# North Byron Parklands Cultural Events Site **Response to Submissions Addendum**

PJEP Ref: North Byron Parklands\_RTS\_Addendum\_25Sep18

**Figure 1:** Existing Road Near South West Car Park (Source: SIX Maps)

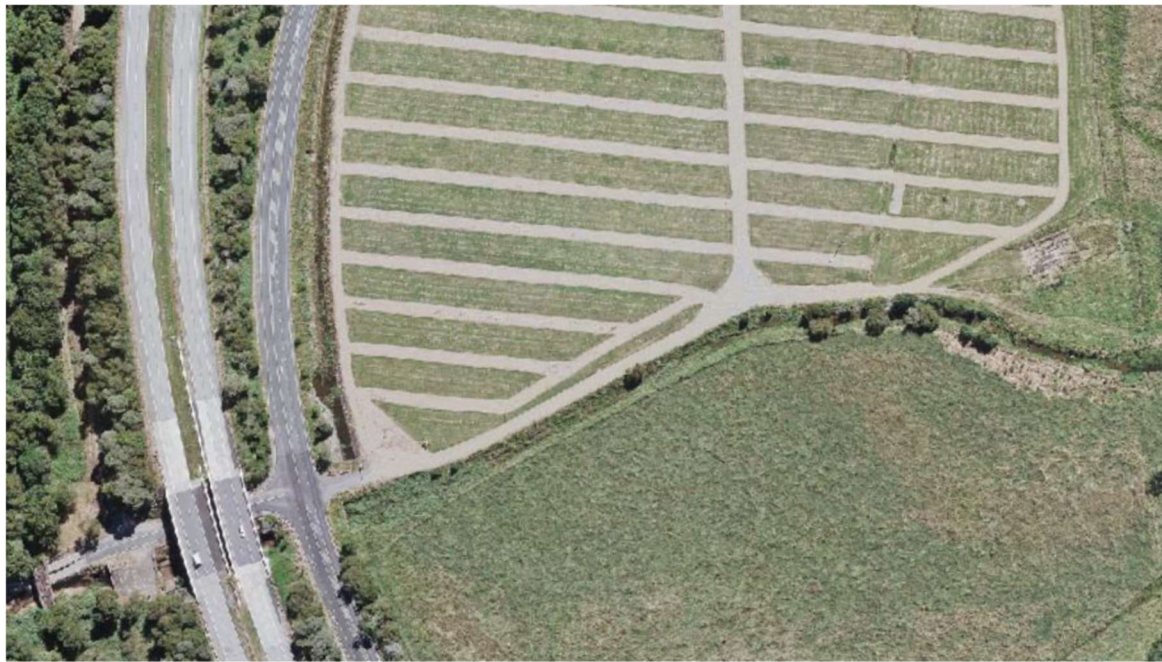
*“The RTS has not adequately demonstrated that it complies with the Guidelines for Controlled Activities on Waterfront Land (NRAR 2018). Specifically, the RTS has not incorporated vegetated buffer zones as requested in previous advice dated 16 February 2018. The proposal should include a:*

- *20 metre vegetated buffer between Yelgun Creek (3<sup>rd</sup> order stream) and road near south west carpark, and*
- *10 metre buffers between:*
  - (i) proposed structures and the top water level of the existing dam near the conference centre,*
  - (ii) conference centre car park and 2nd order stream, and*
  - (iii) proposed amenities near existing bus stop (at western car park) and the top bank of the nearby watercourse.”*

With regard to the suggested ‘20 metre vegetated buffer between Yelgun Creek (3<sup>rd</sup> order stream) and [the] road near [the] south west carpark’, it is noted that this event laneway road has already been approved and developed as part of the existing concept plan and project approval, and forms part of Gate D (see **Figure 1** below).

The proposed development does not involve any changes to this road alignment, as indicated on the civil design plans (see Appendix C of the EIS). As outlined in the EIS, the southern parking area (and this roadway) is only used during the larger events on site (ie. up to 13 days a year).

Consequently, it is considered that providing the recommended buffer is not reasonable, practicable or warranted.

It is noted that the road is located immediately adjacent to a highly modified section of Yelgun Creek, constructed by RMS as part of the Yelgun to Chinderah Pacific Highway upgrade. Prior to the completion of this upgrade in 2005 the existing road was used by previous landowners as an access road to the old Pacific Highway (now known as Tweed Valley Way).

Given that the proposal does not involve any changes to the road alignment, it is also not considered reasonable to retrospectively require riparian offsets for this road, as per the *Controlled Activities on Waterfront Land* guidelines.
